TENDER NO: 2022-16

Market Place West Phase III Revitalization

ADDENDUM

ADDENDUM NO:

2022-16 - MARKET PLACE WEST PHASE 3
TITLE: STRUCTURE DIMENSIONS
DATE: DECEMBER 6, 2022
DRAWN BY: MB
SCALE: 1:50

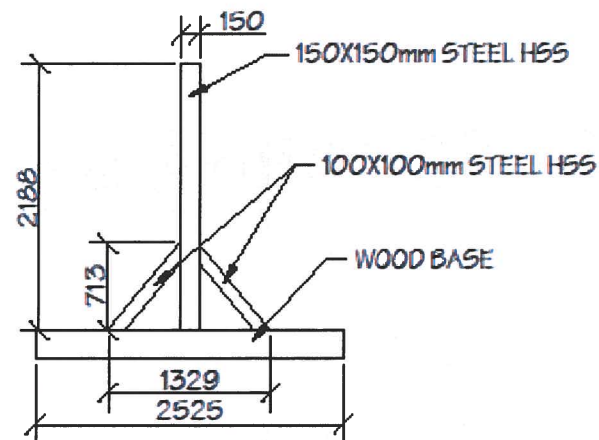
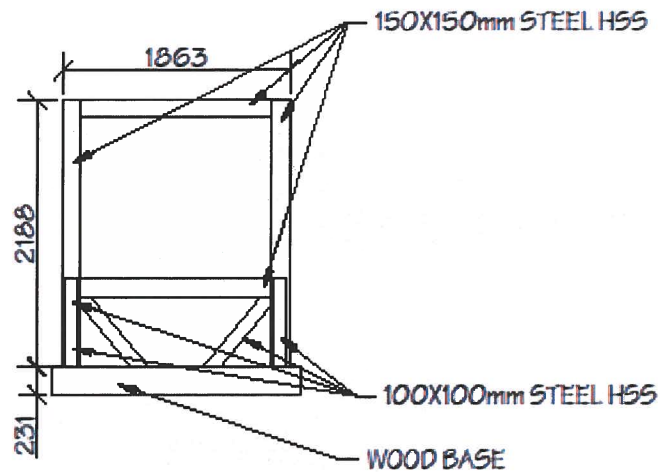
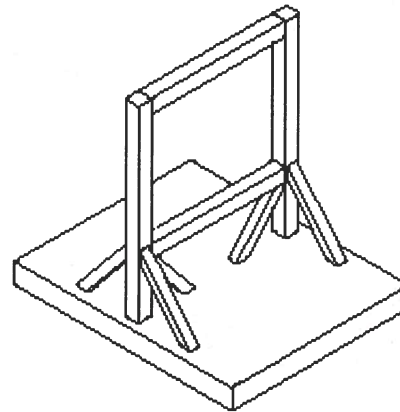
Question – Do you have any information on the bell to be relocated ie. Weight, dimensions, lifting points, is the bell anchored to the pad? Photos?

Answer – Please see attached addendum sketch for dimensions (all in mm), see attached photos for reference. We do not have the exact weight. The bell is not anchored to the pad.
